## Models UKOPLX1004QDU e UKOPLX1004STU

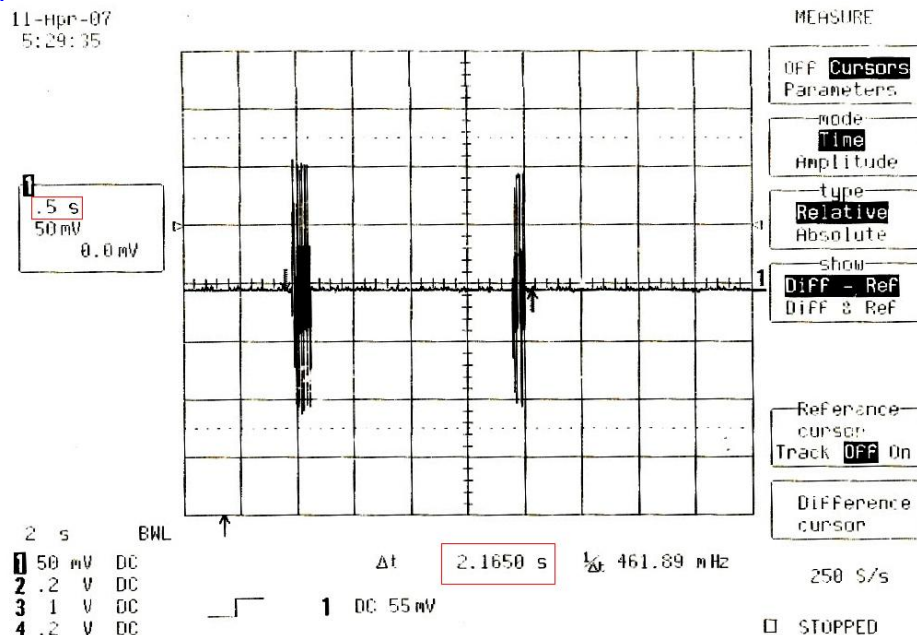
4) From the user manual we could not infer that 15.231 (a) (2) can be fulfilled. Please send us the corresponding plot to prove that transmission will be ceased in 5 seconds.

Please choose the worst case (also explain why it is the worst case) as the test report plot.

In figure you can see a plot of a transmission of APB mode, with pseudorandom time forced to max and so this is the worst case.

The total transmission time is about 2,2 sec maximum.
